Initial Study / Mitigated Negative Declaration – Response to Comments

SCH No. 2024060684

Long Beach Utilities Department

October 2, 2024

Figure 1-7. Proposed SOI Amendment and HGS Annexation

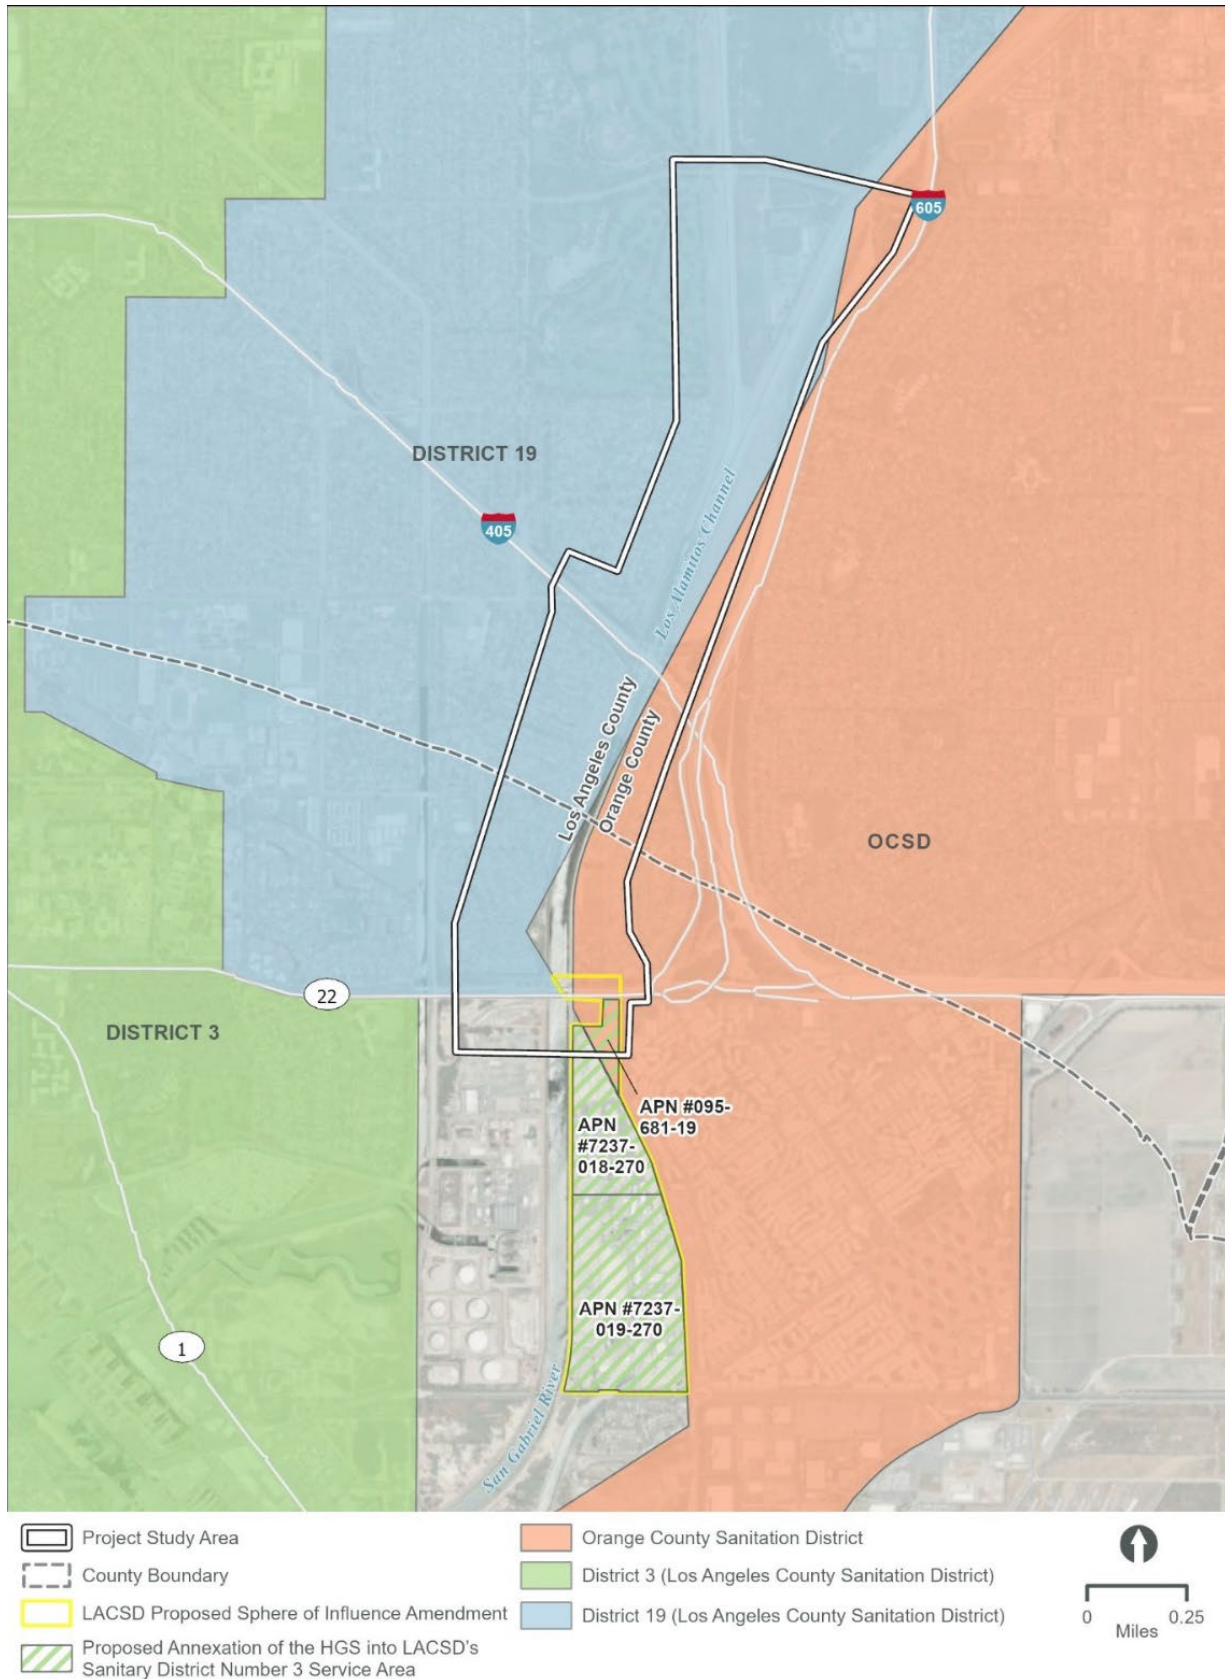
LACSD-4 This comment introduces a second letter from LACSD and provides introductory remarks and a brief description of the proposed Project. The comment also states that the two parcels where HGS is located are outside the jurisdictional boundaries of LACSD and will require annexation into County Sanitation District No. 3 before sewerage service can be provided.

Influence. This comment suggests that it be annexed into County Sanitation District No. 3. Based on this direction, LBUD has revised the IS/MND to indicate annexation into County Sanitation District No. 3 and not No. 19. Refer to Section 3 of this document for the revised text. This would be considered a minor clarification to the IS/MND and does not constitute a substantive change to the analysis. This revision would not require recirculation of the IS/MND (State CEQA Guidelines Section 15073.5).

Figure 2-7 of the IS/MND is revised to show annexation of LADWP's HGS into LACSD's Sanitary Sewer District No. 3.

Figure 2-7 of the IS/MND is revised to show annexation of LADWP's HGS into LACSD's Sanitary Sewer District No. 3.
